Our ref: EJM/CE/17016-02

RE: THE FUTURIST, LIME STREET, LIVERPOOL

Photograph 7: Suggested position of dismantling

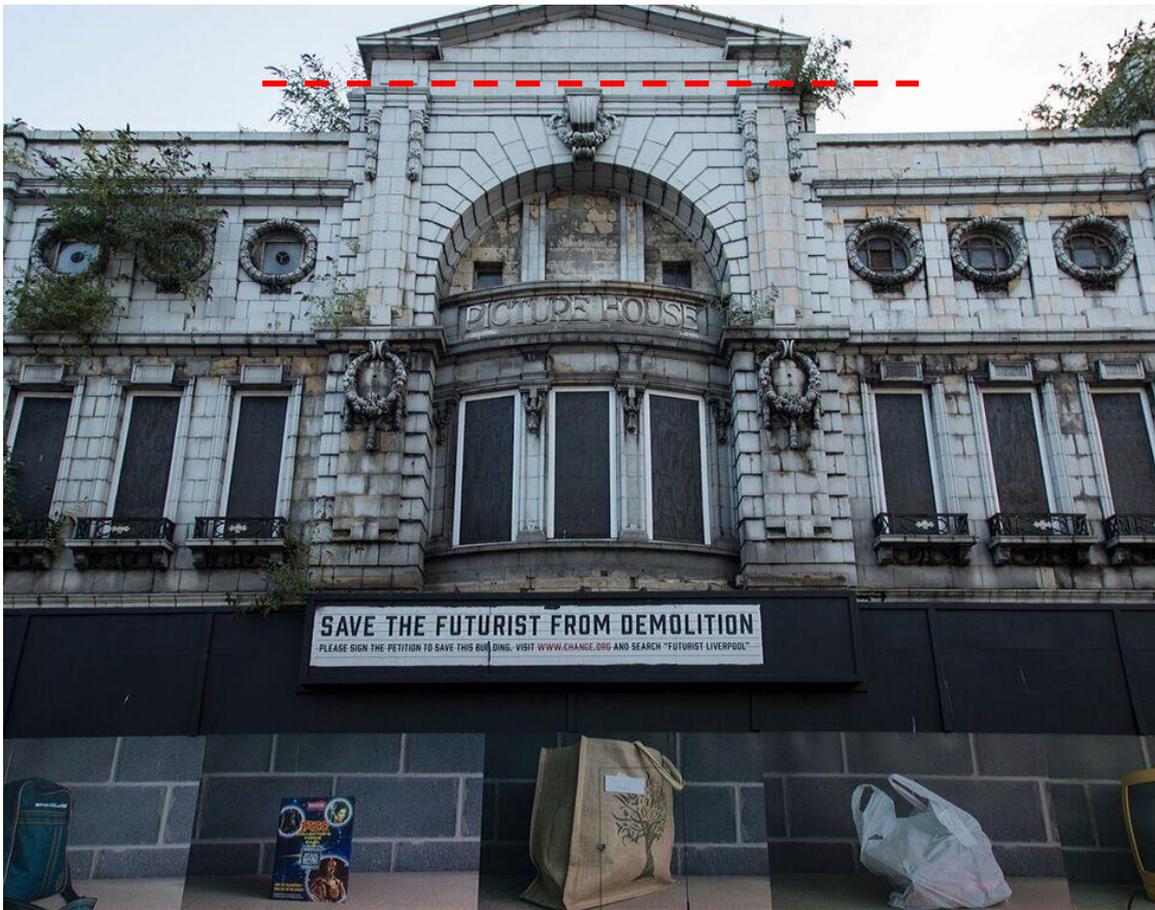
I note that they intend to only take the minimum amount of structure down at present but suggest that this will need to include the central arch at second floor level. Firstly I suggest that the extent of dismantling should be limited down to just above the string course to the pediment as shown on the marked-up photographs appended as photographs 7 and 8. This is the position where the wall steps out in thickness at the rear, as well as where the engaged piers or pilasters exist to the front elevation, which should offer greater stiffness to the elevation. If necessary it should be possible to provide some additional lateral restraint from the rear in the form of scaffold raking buttresses – I note that Greg Allen in the sixth paragraph of his email dated 26th April is suggesting the scaffolding contractor will return to assess some internal works so it could be part of these, but of course will need to be assessed once the roof structure behind is removed as indicated.

This will leave sufficient masonry over the central arch for this to be self-stable. However it should also be possible to insert temporary centering below the arch if necessary, and back propping below in the foyer, although I suspect this is unlikely. It will be important to cap over the head of the wall to protect this and ensure water ingress into the wall core is minimised.
